SACRAMENTO CITY PLANNING COMMISSION
 1231 "I" STREET, SUITE 200, SACRAMENTO, CA 95814

LOCATION: 4353 73rd Street

PROPOSAL: The applicant is requesting the necessary entitlements to create two deep lots in order to construct an additional unit on each lot as well as to demolish an existing house on a land locked lot and reconstruct the unit. A total of five units will be located on the 0.56± acre site.

(P91-032)

**LOT LINE ADJUSTMENT
A PORTION OF LOT 9540 OF 7 B.M. 40
CITY OF SACRAMENTO, CALIFORNIA
JANUARY, 1991 SCALE: 1"=20'**

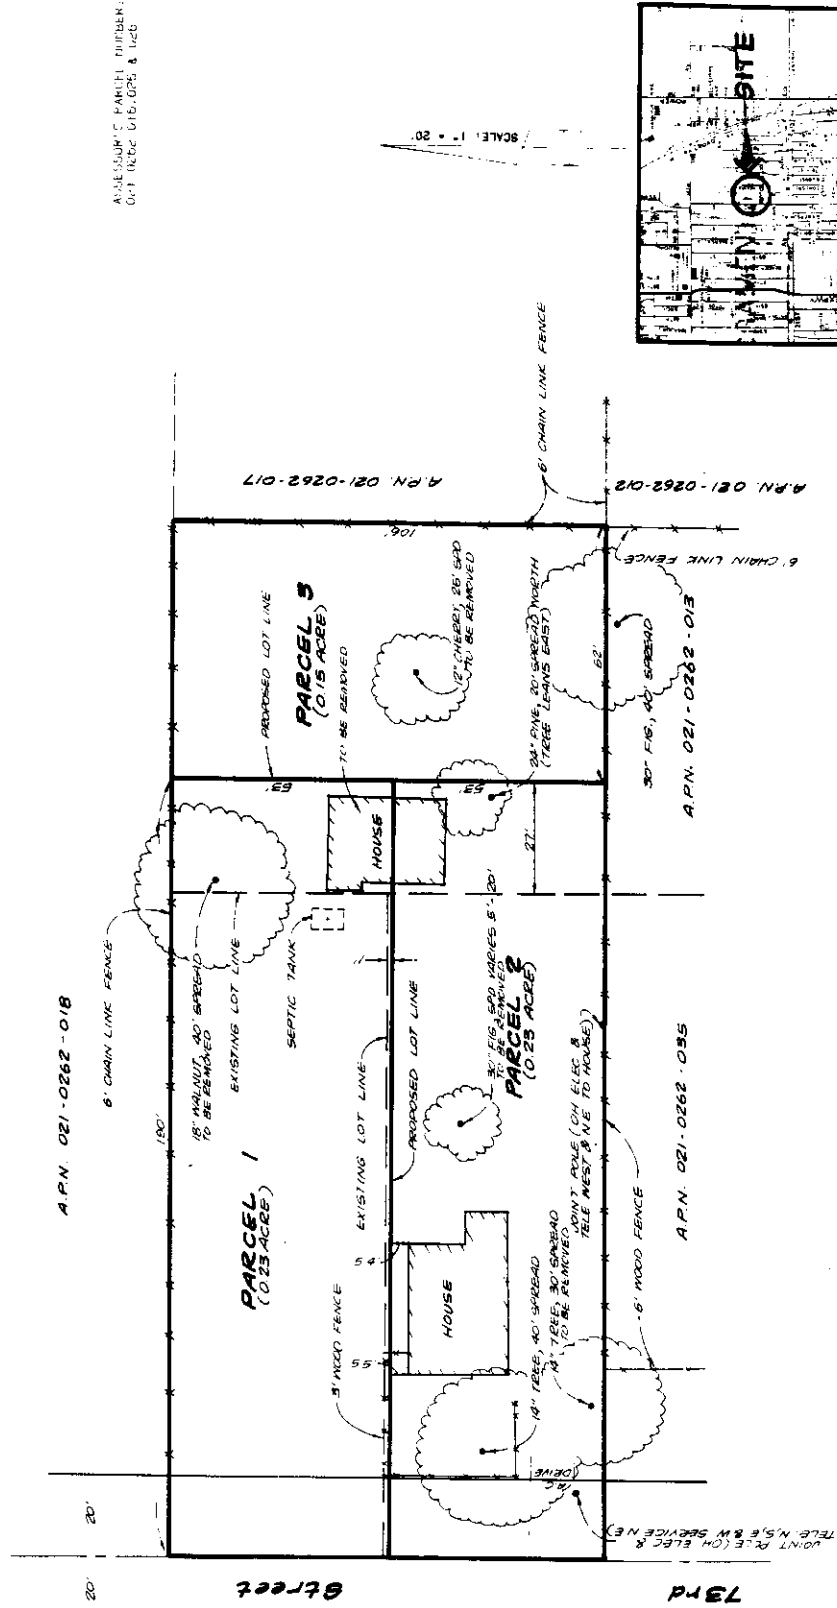
The site plan indicates seven trees located on the site (Exhibit A). Of the seven trees on the site the applicant proposes to remove four of the trees. Staff recommends additional trees be planted on the site to replace the trees to be removed. The trees to be planted should be a minimum 15 gallon deciduous tree of the applicant's choosing.

1. A minimum 15 gallon deciduous tree shall be planted when any tree is removed from the site, except as noted in the mitigation measures which requires two 24 inch box trees to be planted if the walnut tree is damaged by the development of the site.

2. A landscaping plan shall be submitted for review and approval of the Planning Director prior to issuance of building permits. The landscaping plan shall indicate the trees to be removed and the location of the trees to be planted.

EXHIBIT C SITE PLAN

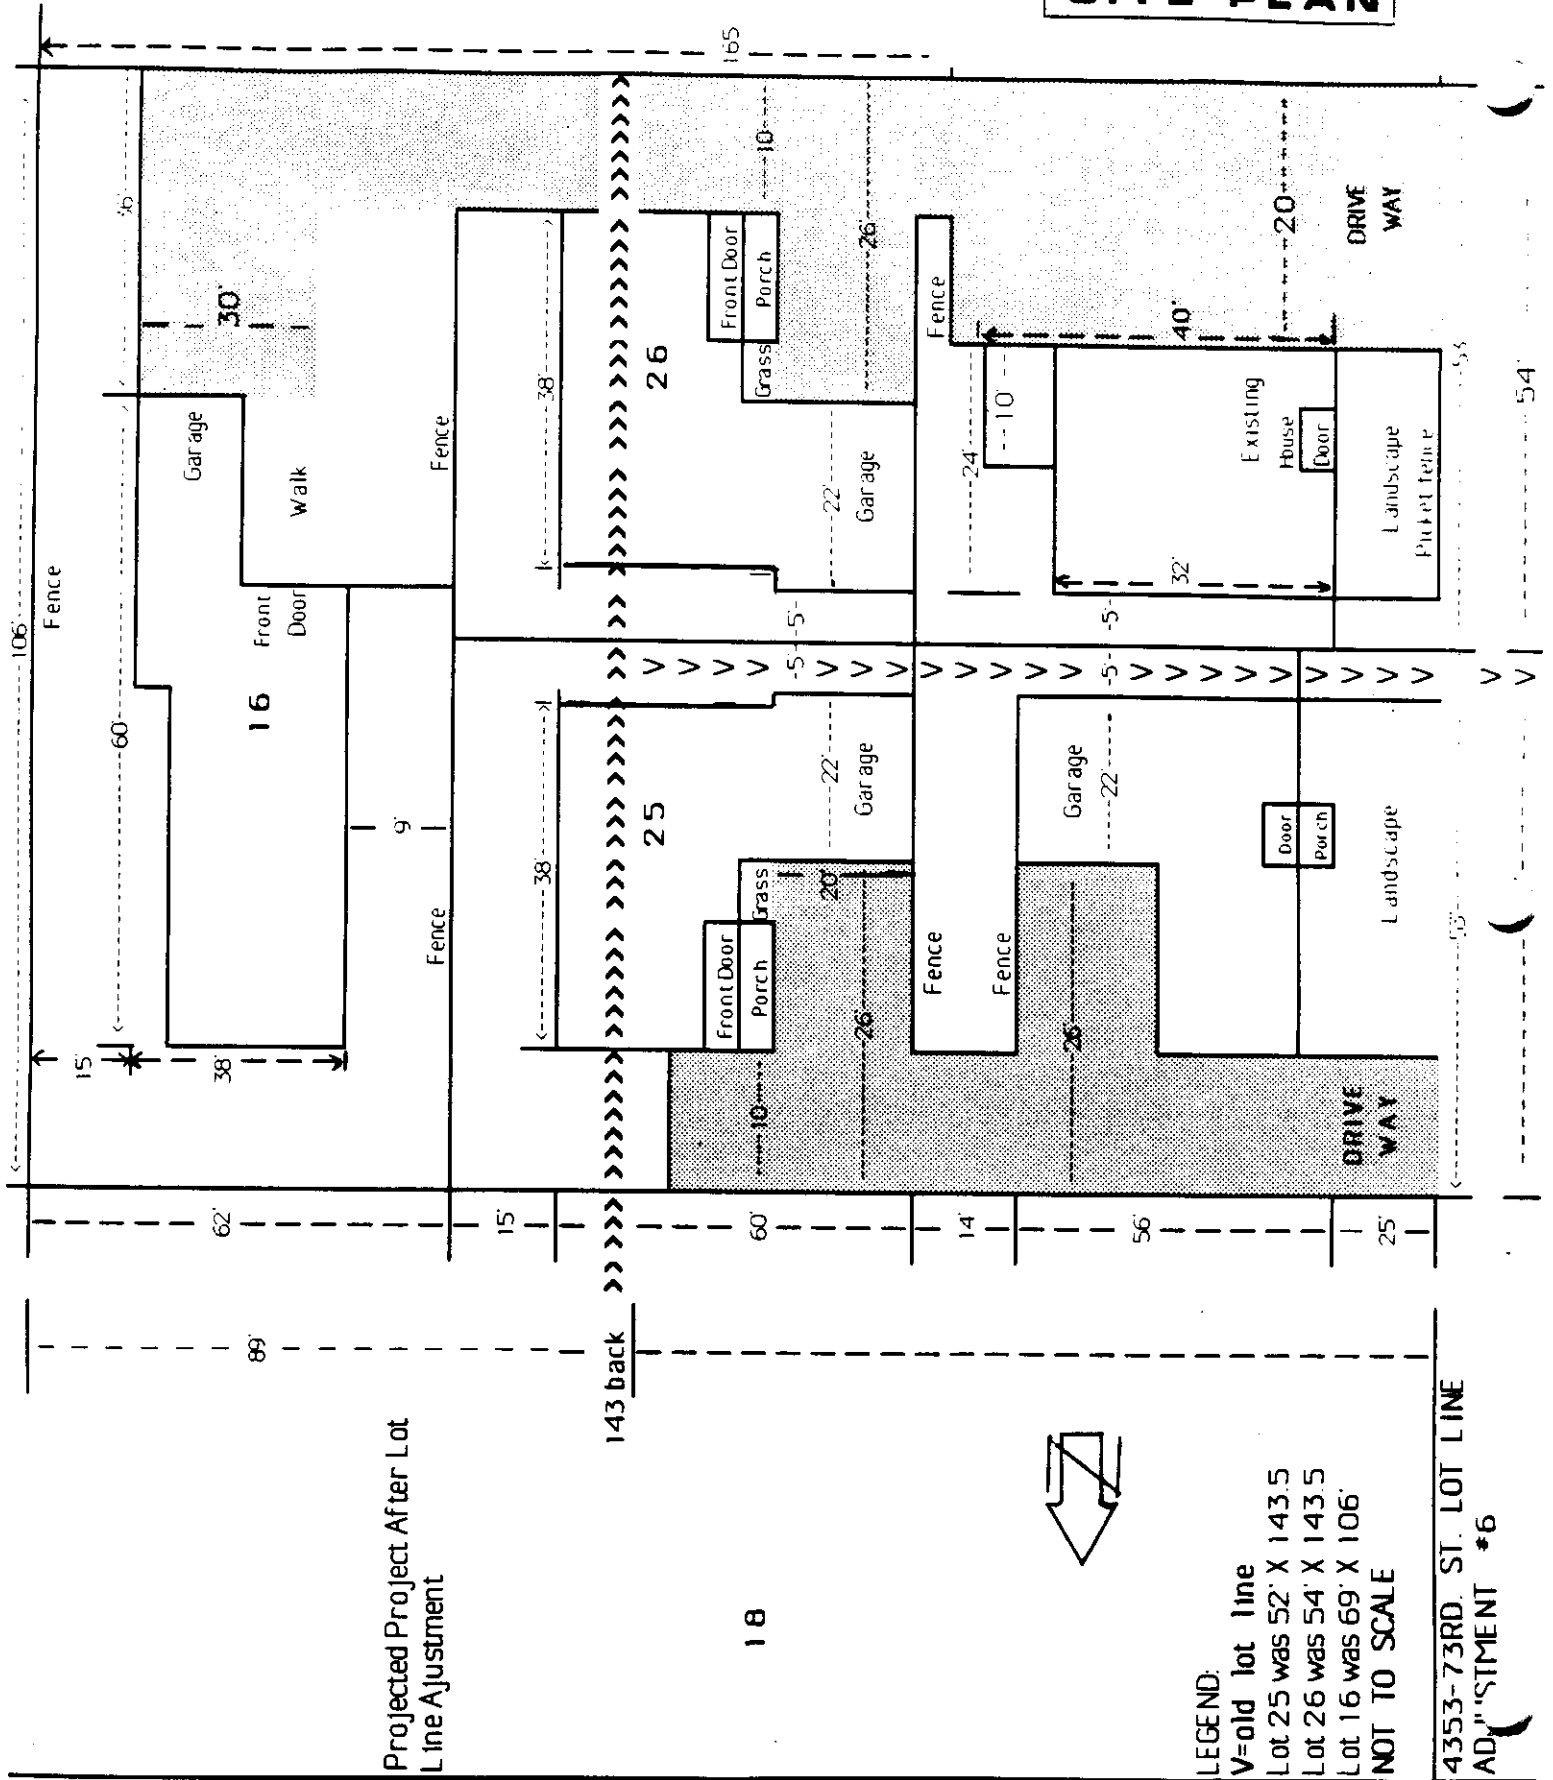
The site plan (Exhibit C) for Parcel One indicates a driveway to be located along the north property line for access to the two units. Parcel Two and Three will have a driveway located along the south property line. A driveway currently exist in this location. The driveway for these two lots will be 20 feet wide in order to accommodate a fire truck if necessary. The driveway will be reduced to a 10 foot width, 114± feet from the front property line. The applicant will provide an easement over this driveway for the rear lot. The garages for the front lots will be located in the middle of the lots and be recessed towards the common property line (north/south lot line). This enables the vehicles to maneuver forward and exit the site instead of backing out the full length of the driveway.

The proposed site plan for the three lots meet all setbacks, lot coverage and court yard requirements. The existing house on Parcel Two is currently setback 25 feet from the front property line. Public Works is requesting an additional two feet of right of way be dedicated on 73rd Street to provide for a 22 foot half street. In dedicating two feet for right-of-way the existing house will not be 25 feet from the front property line. Since this unit is already existing a variance would not be required. The proposed unit on Parcel One can be shifted back two feet to provide the 25 foot setback while still providing adequate courtyard area between the two units on the site. Another alternative would be to readjust the property line two feet to the east and shift both units on Parcel One to the east. This would allow more open space for

the units on Parcel One while still providing adequate setback for the unit on Parcel Three.

5. The lot line adjustment shall be redrawn to shift the rear lot line two feet to the east in order to accommodate the two foot of additional right-of-way.

6. Provide standard improvements along 73rd Street to the satisfaction of Engineering Development.
7. The proposed front unit on Parcel One shall maintain a 25 foot front setback from the new property line.

EXHIBIT E

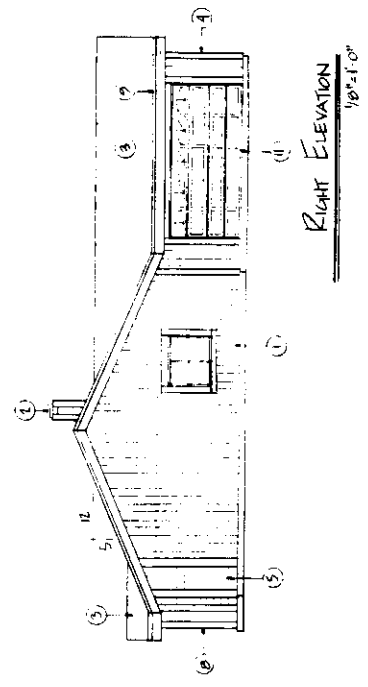
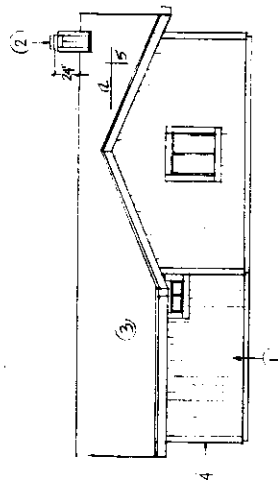
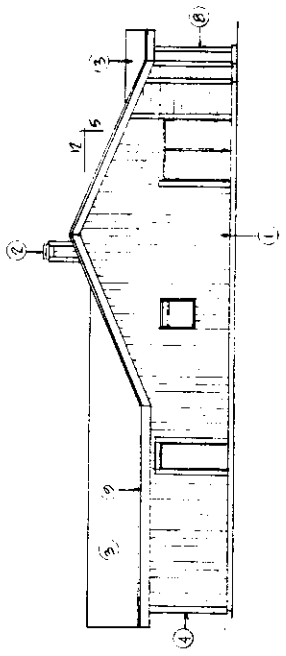
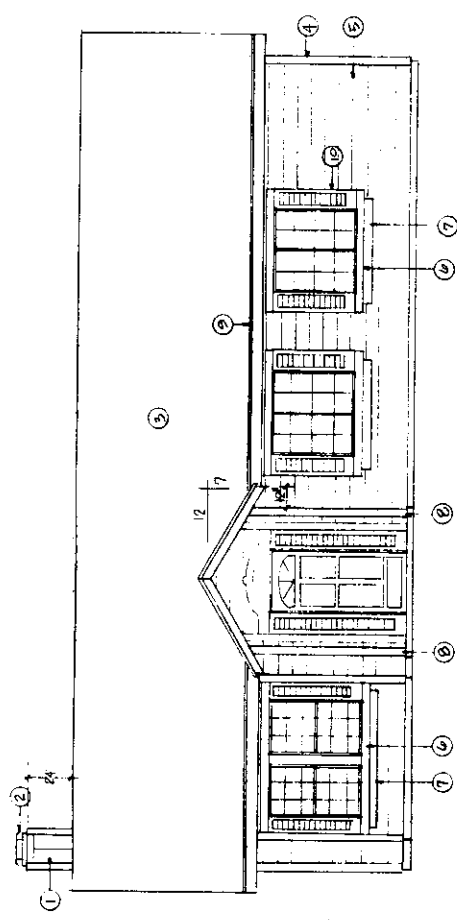
The elevations have been reviewed by the City's Design Review staff. Staff finds the decorative shutters around the window and door, grid windows and decorative trim around the door provide an interesting focal point for the front elevation (Exhibit E & G). Staff recommends the units be approved as submitted with the modifications that the siding on the chimneys be a lap siding to match the front of the units and a 25 year laminated dimensional shingle roof be required on all four of the units. Staff also suggests the following changes to the unit located on Parcel Three (Glendora Elevations- Exhibit I); the entire front elevation be lap siding, a grid front window, minimum six panel entry door and a metal sectional garage door be provided.

9. The proposed units on Parcel One and Two shall be built per the submitted elevation plans (73-F & 73-M) which include the decorative shutters around the window and entry door, the decorative trim over the entry door, the grid window and panel entry door.

DRAWN BY CALIFORNIA CADD 1111 1/2 ST LOS ANGELES, CALIF. 90012 PHONE (213) 475-1111 TELEX 980000	SHEET NO. 2	PROJECT NO. 9
	DATE 11/1/74	PLAN NAME THE GENDORA
AS SHOWN (Indicates changes from previous sheets)	P.O. BOX 670 ELK GROVE, CALIFORNIA 95624 (916) 685-8514	ELEVATIONS (SLAB)

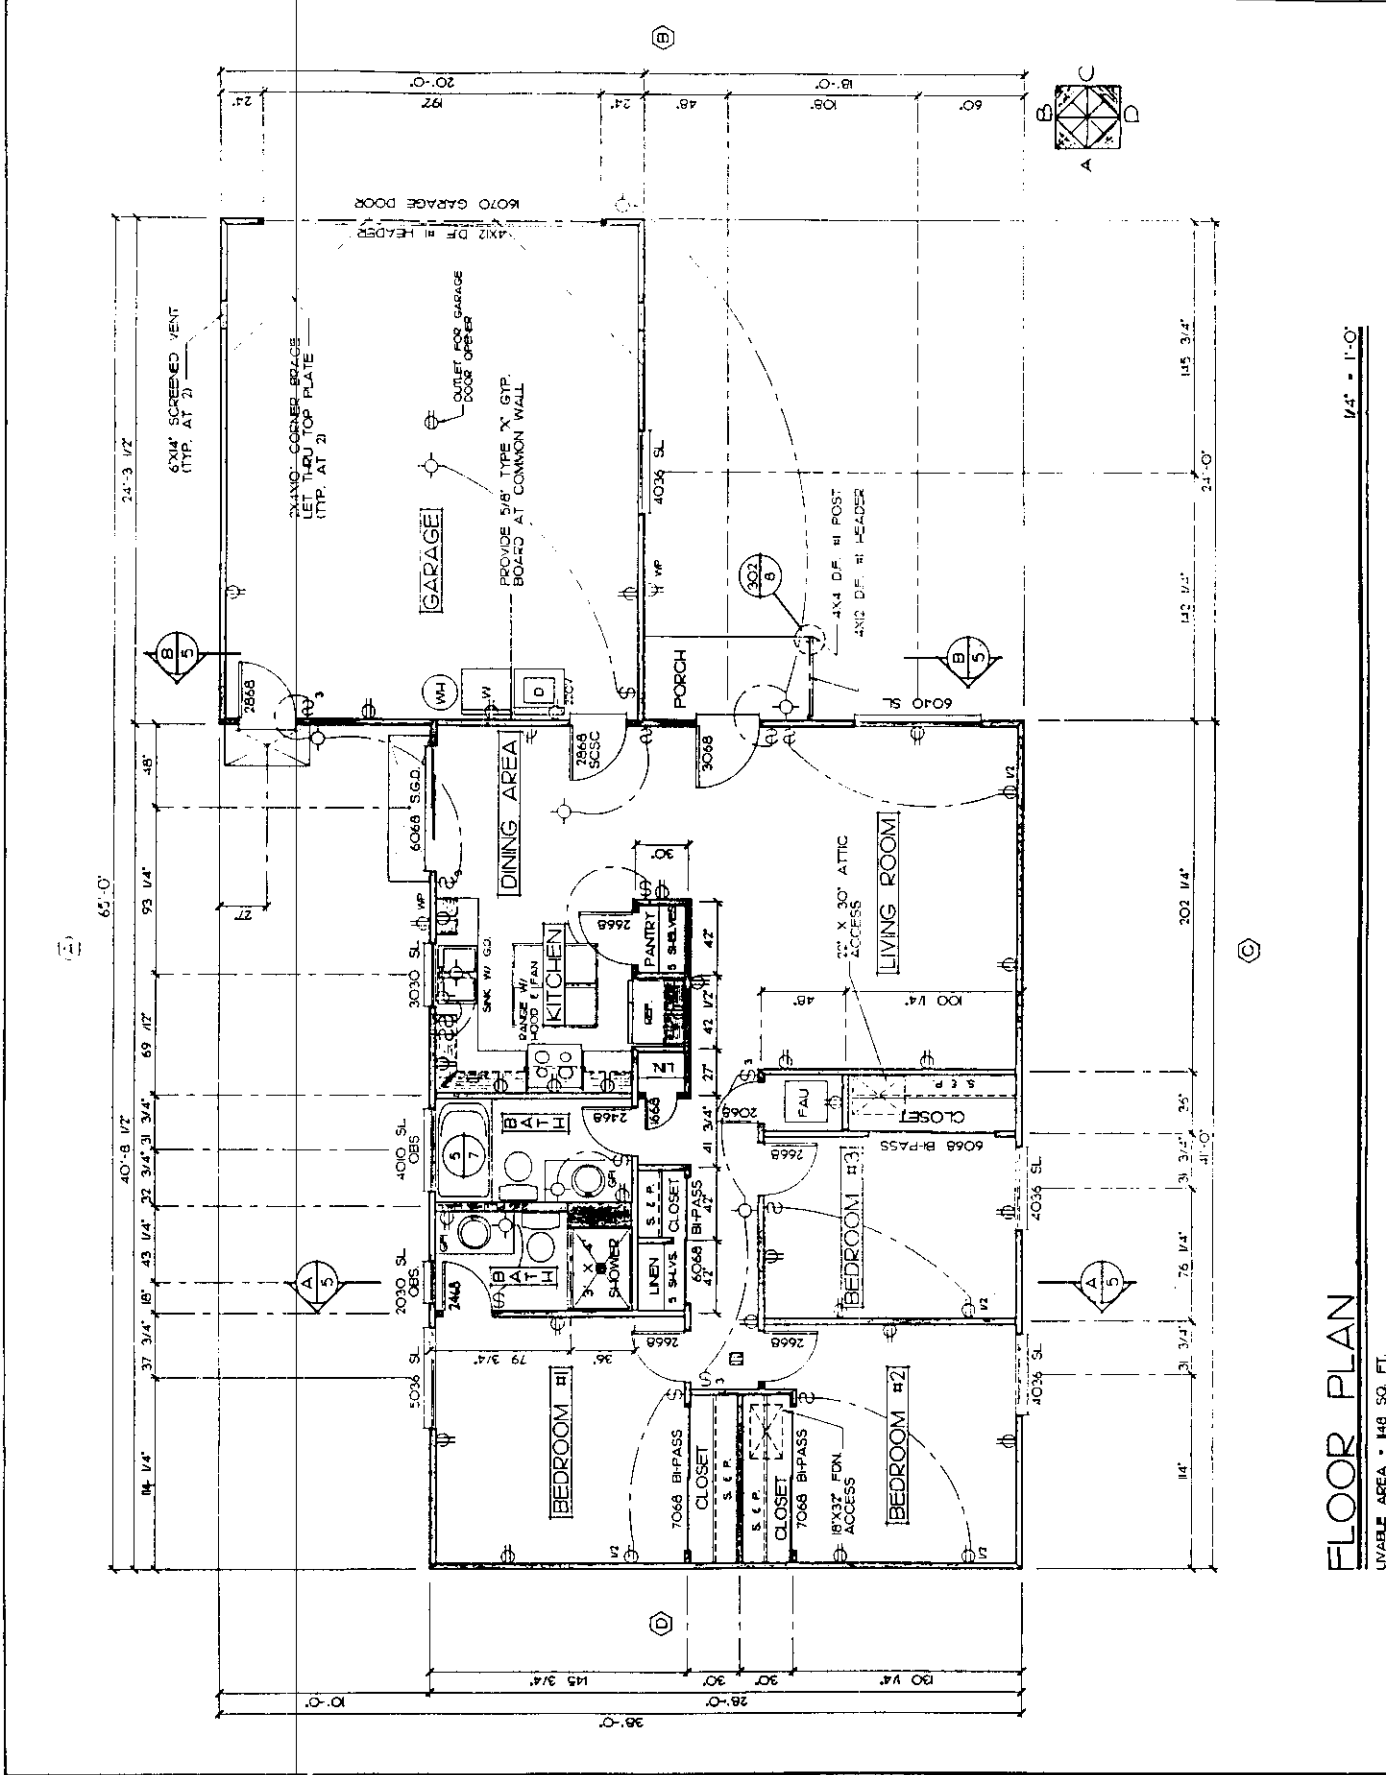
1/2" minimum to parallel door as provided

Grid Window to be provided

8. The front elevation (Glendora Elevation) as proposed on Parcel Three shall be revised to include lap siding on the entire front elevation, a grid front window, minimum six panel entry door and a metal sectional garage door.
